AMBERLY MOTEL

GRADING AND DRAINAGE PLAN

AMBERLEY SUITE HOTEL
DETAIL SHEET

CHANNEL SLOPE PROTECTION 2

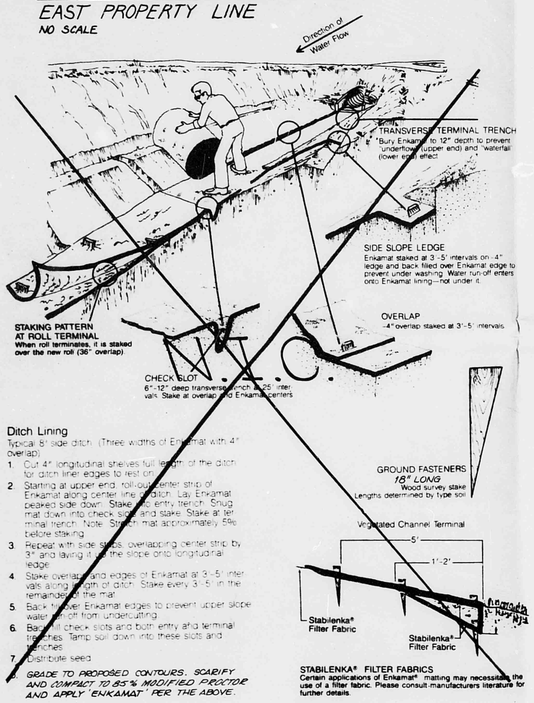
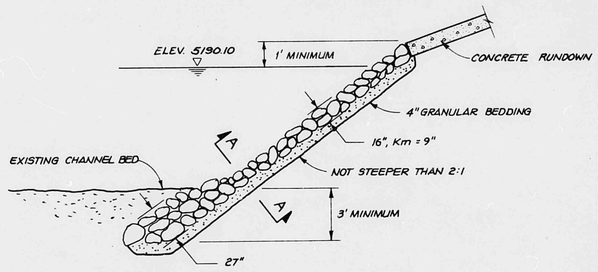
2. SUBSTITUTED DUMPED ROCK RIP-RAP FOR "ENKAMAT" SLOPE PROTECTION P.W.C. 2-26-85
